**Part: SE141-115 / MODULAR COIL, TYPE B**

Drawing ID: SE141-115                      Revision: 8

MCWF FLANGE INSERT

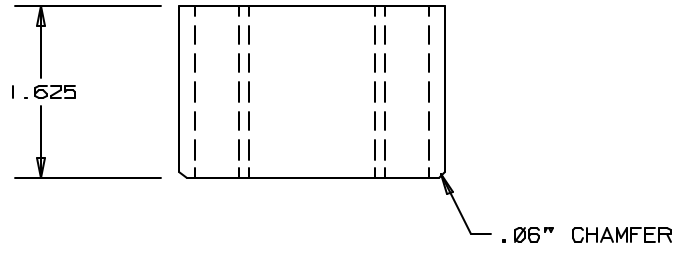
Problem: Sheet 5, zone D4.  
8 of the 1.375 threaded holes on datum -E- are out of position by a 1/2 inch (holes 19 thru 26).

MTM RECOMMENDS REPAIRING HOLES PER ATTACHED REWORK PROPOSAL.

MTM's re-work proposal (attached) is accepted, with the understanding that the insert will be made of Stelalloy ( to assure that magnetic permeability and strength requirements will be met). The strength of this repair is not an issue since the insert is threaded into the flange with 2.5-6 UNC threads and then tack welded in place.
